**STAFF REPORT: FEBRUARY 7, 2024 MEETING**

**APPLICATION NUMBER: HDC2024-00064**

**ADDRESS: 640 W. WILLIS, AKA "WEST WILL"**

**SCOPE: REPLACE WINDOWS**

Front:

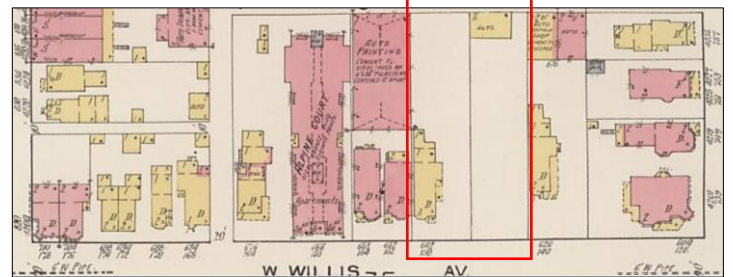
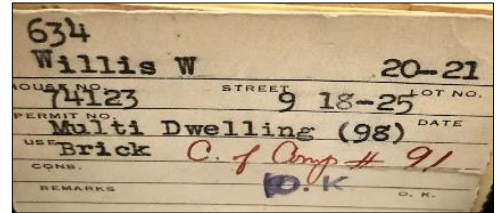
- Replace “all windows and frame”
- Existing wood double-hung units with six-over-one pattern will be replaced with new wood windows.
- Install Weathershield premium aluminum-clad wood double-hung windows, color: TBD.

- Replacing existing incompatible, non-historic windows with similarly incompatible new windows does not meet the Standards.
  - Upon determination that the front elevation windows are not historic, it is staff's opinion the selected Weathershield replacement windows will be compatible with the historic appearance of the building. The selected window line offers simulated divided-light "grilles", butt-joint cladding, and wood jamb liners (so the liners can be easily painted to match the cladding color, unlike the example shown above).

- The existing steel windows flanking the front entrance will remain in place.
- The 5/8” grille will be selected for the six-over-one upper sash, and the exterior cladding color will be submitted for staff review.
- The completed window order(s) for the building will be submitted for staff review.
- The existing wood brick mould will remain in place within each window opening and will not be covered with aluminum trim.

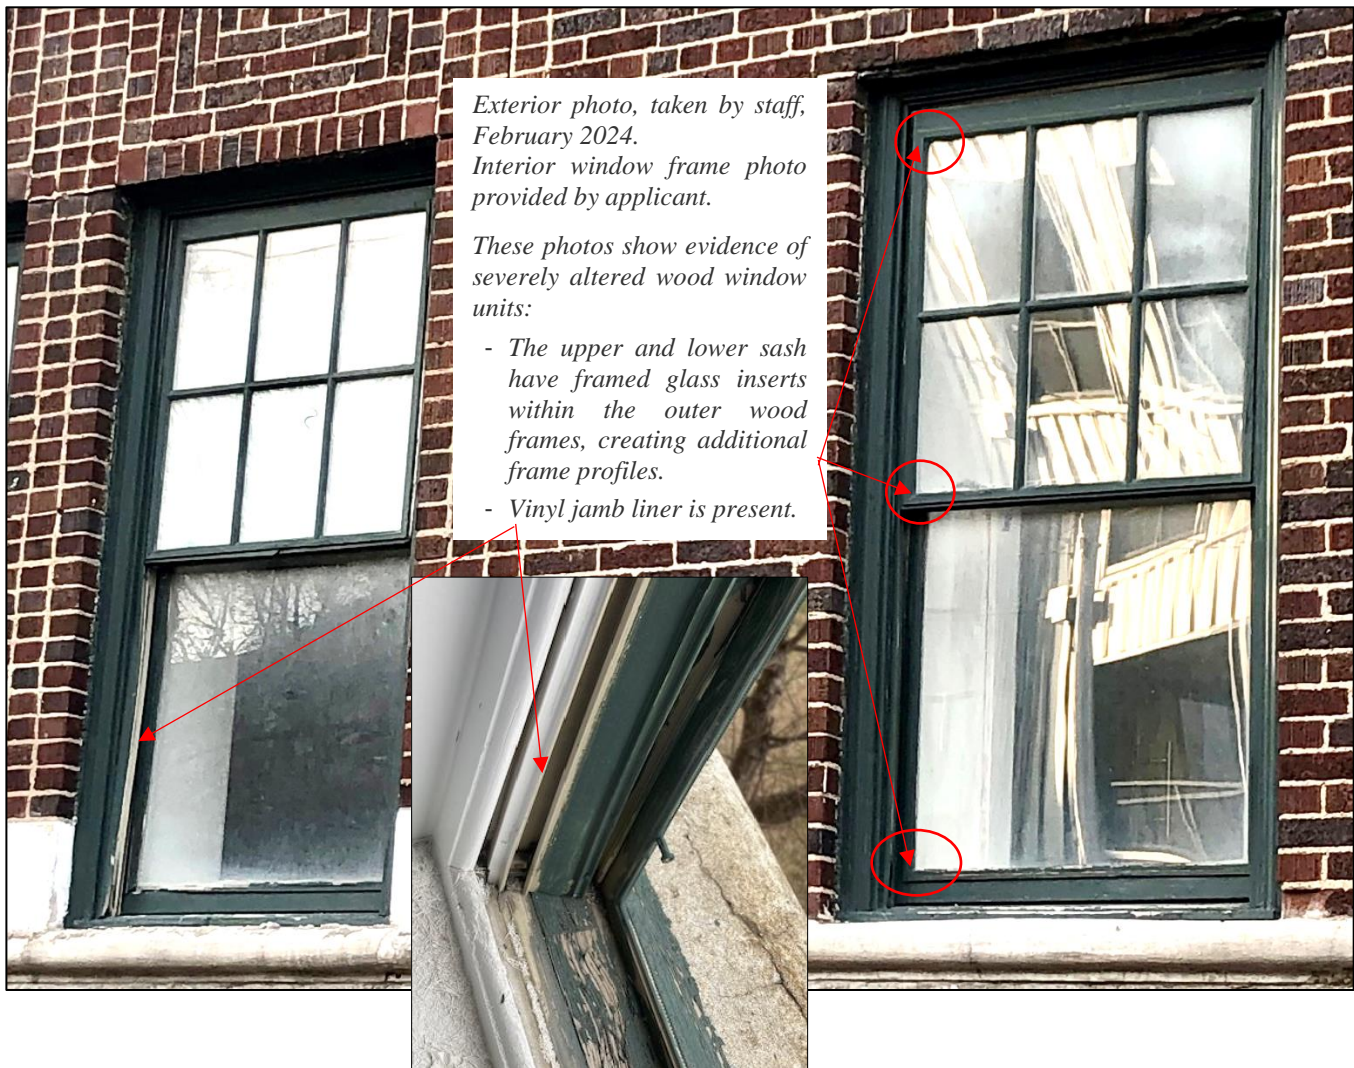
- Upon review of the applicant's documents, staff requested dimensions of the existing wood windows and the proposed Weathershield aluminum-clad wood windows.

Existing	Proposed	Change	Comments
Top Rail	2-7/8"	2-5/8"	1/8" smaller	Difference will not be perceptible
Meeting Rail	1-1/2"	1-7/8"	3/8" larger	Will only be minimally perceptible from the basement and first floor windows. Otherwise looking upward at an angle, increased 3/8" thickness likely won't be that noticeable.
Bottom Rail	3"	3-3/8"	3/8" larger	Same comments as above.
Stile	1-3/4"	1-7/8"	1/8" larger	Will not be perceptible.
Muntin/grille	1/2"	5/8"		Only one minimally profiled grille is available as a simulated divided light.
